ALKS Lateral Detection Range –

why existing provisions already ensure sufficient sensing ranges to assess the traffic dynamics in the second to next lane

Par. 7.1.3.
„Cover the full width of the lane adjacent...“

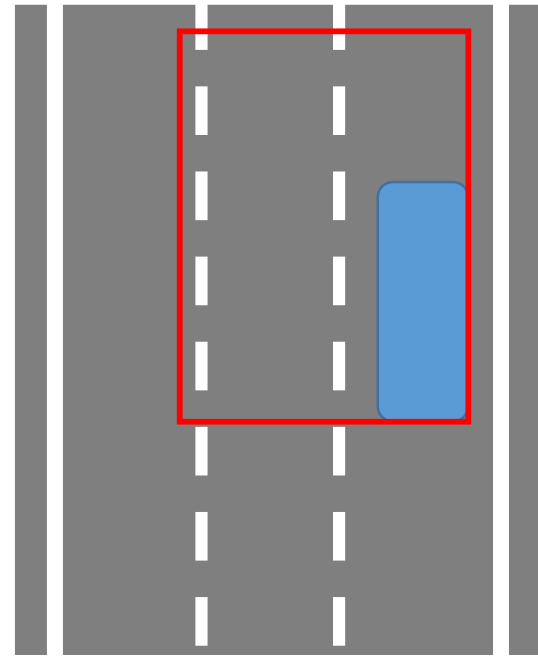
Par. 7.1.3.
„Cover the full width of the lane adjacent...“
applies even when not driving in the center of the lane

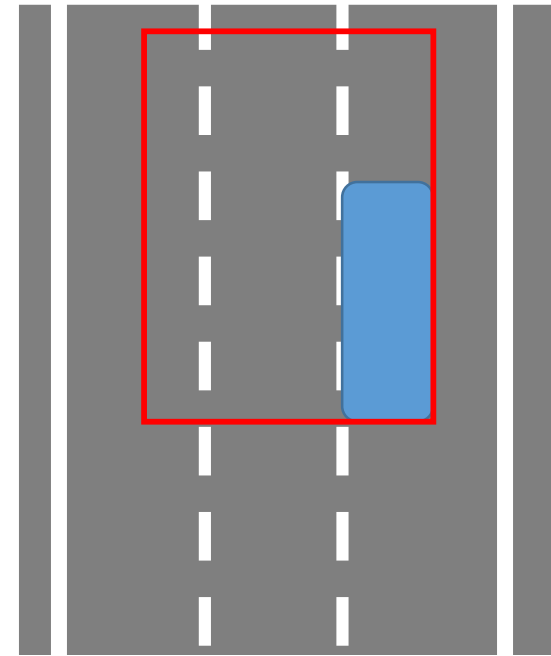
So even with current provisions ALKS will „look“ into the second to next lane already.

By the time a LCM starts, the ALKS will be able to assess the traffic dynamics also in the second to next lane.

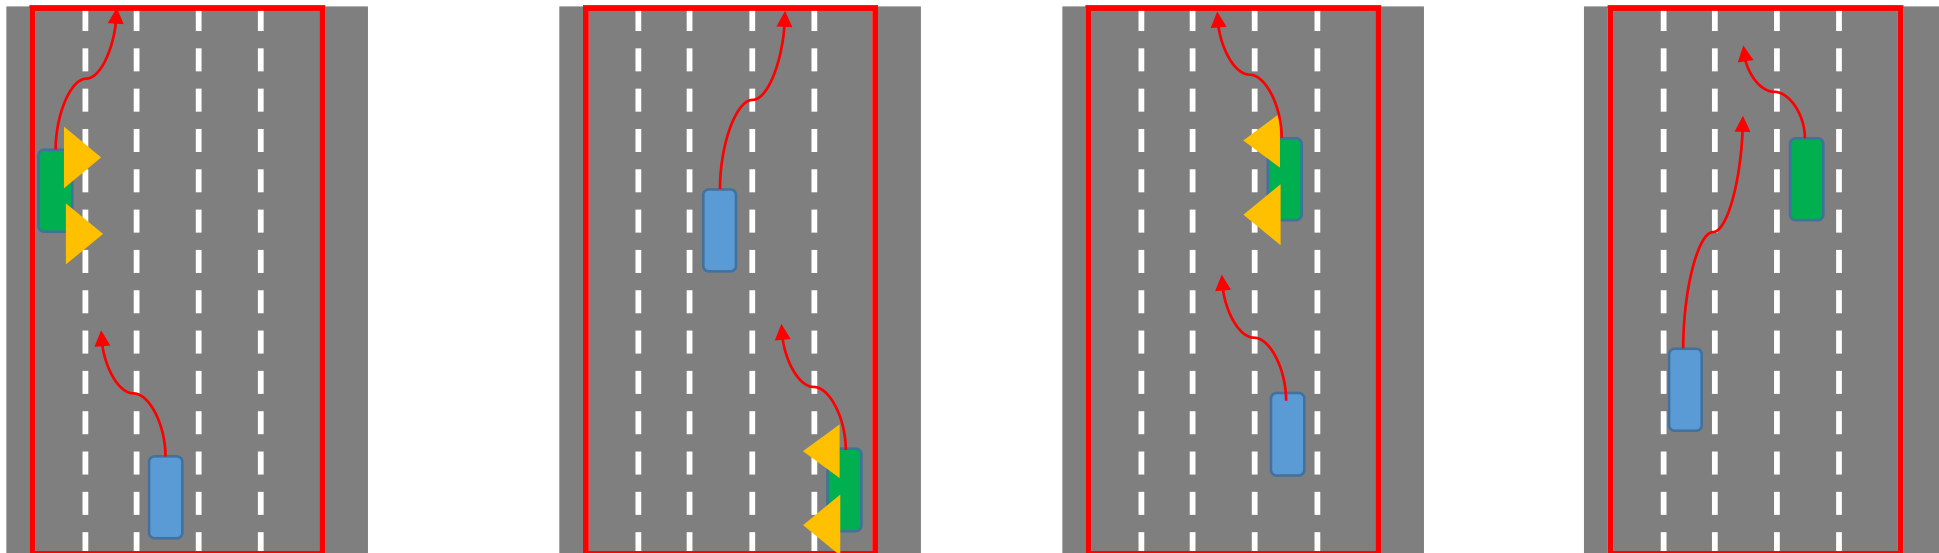
The currently discussed amendments:

“[(d) There is no other vehicle which is activating direction indicator to come to the target lane (except following vehicles at and near merging and departing lanes).]”

“[(c) Across the full width of its own traffic lane, the full width of the traffic lanes immediately to its left and to its right, the full width of the lane next to the target lane, up to the limit of the forward side and rearward detection range, if fitted to perform a LCP.]”

would prohibit LC, even when fully uncritical (e.g. a much faster vehicle changing into the target lane 150m ahead, or a much slower vehicle following behind), while a safety risk where a LC is performed unindicated is not adressed:

While existing provisions already establish what is needed to ensure safety, we could emphasize this scenario by introducing the provision in blue:

- 5.2.6.1. A LCP shall not cause an unreasonable risk to safety of the vehicle occupants and other road users. LCPs shall only be performed in an uncritical way as described in paragraphs 5.2.6.1.1. and 5.2.6.1.2.**
- 5.2.6.1.1. The intervention shall not cause a collision with another vehicle or road user in the predicted path of the vehicle during a lane change.**
- 5.2.6.7.2. Assessment of the target lane for a regular lane change
A regular LCP shall only be initiated if the ALKS vehicle is able to fulfil the requirements of par. 5.2.4. and 5.2.5. also with respect to the target lane.**
- x.x.x. A LCM shall only be initiated when the relevant area of the target lane is expected to remain unoccupied throughout the manoeuvre (e.g. there is no other vehicle in the second to next lane expected to change lanes on a conflicting trajectory).**
